NUMBER: 09-005-17 REV. B

2.0L Coolant Hose O-Ring Replacement

2017 (GA) Alfa Romeo Giulia

Fig. 1
Turbocharger Coolant Hose

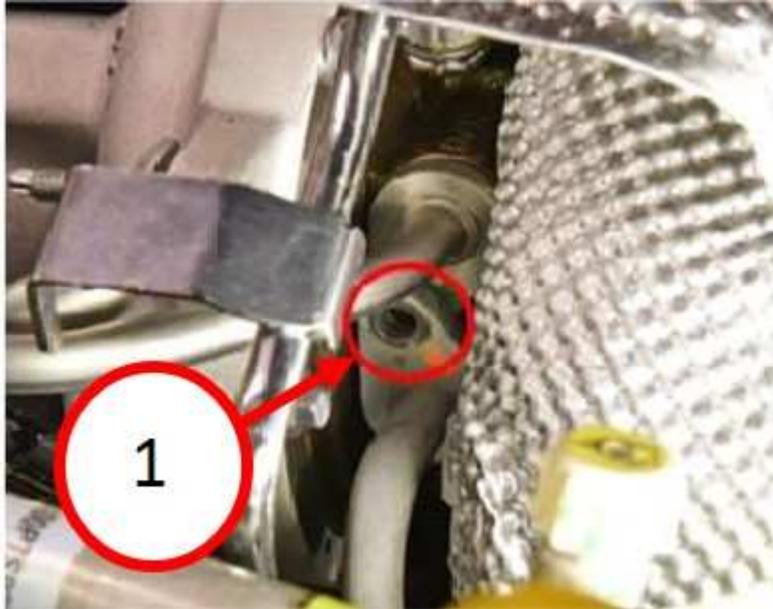
1. **Remove the coolant inlet tube (lower position) to allow the outlet tube (upper position) to be removed from the turbo. A black O-ring on the Outlet tube needs to be replaced with an orange O-ring (Fig. 1) .** Refer to the detailed service procedures available in DealerCONNECT> TechCONNECT under: 09 - Engine, 2.0L/Turbocharger System/Lines, Tubes and Hoses, Turbocharger, Oil and Coolant/Removal.

Fig. 2
Turbocharger Coolant Hose O-rings

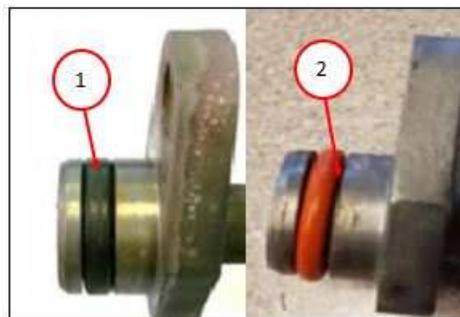
2. Replace the O-ring attached to the end of the coolant return hose (Fig. 2) with the new one listed in Parts Required.

1 - Bad O-ring (Black)
2 - Good O-ring (Orange)
